PROPOSAL FOR DRAFT AMENDMENTS TO REGULATION No. 110

Note: The text reproduced below was prepared by the expert from ISO/TC22/SC25 in order to amend the text of the Regulation with regard to the harmonization of fuelling connectors. A new connector type described in the Standard ISO 14469-2 will be introduced, with a larger cross section than the connector in accordance with ISO 14469-1 and, therefore, permits refueling of the vehicles within significantly shorter time periods. The text is amended in a way that dimensions of the filling unit will be mandatory for new type approvals heavy duty vehicles. The possibility to use of smaller size connector (ISO 14469-1) will still be permitted for heavy duty vehicles. The use of the ISO standard is optional.

Fig. 2: 20 MPa Filling unit Size 2 (receptacle) for M₂, M₃, N₂ and N₃ vehicles

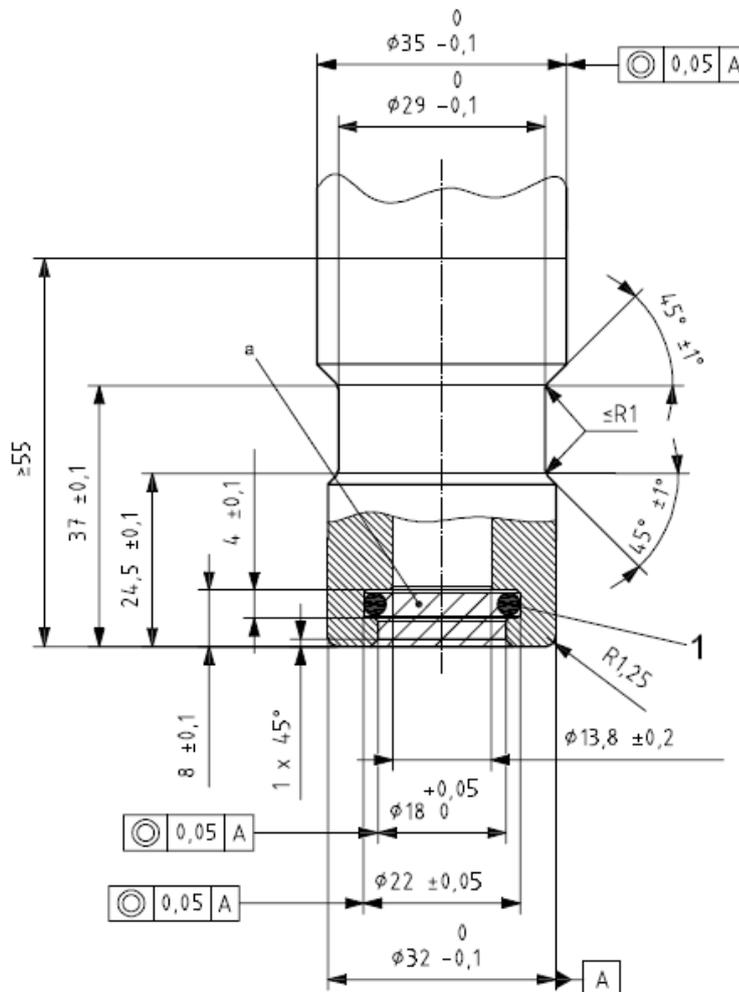
Insert a new paragraph 4.2., to read:

4.2. Figure 2 shows the dimensions of the filling unit for vehicles of categories M2, M3, N2 and N3. 2/

1 sealing ID = $\varnothing 15,47 \pm 0,1$ width = $\varnothing 3,53 \pm 0,2$

Surface roughness < Ra 3,2 μm .

Sealing surface finish: 0,8 μm to 0,05 μm .

Material hardness: 75 Rockwell B (HRB 75) minimum.
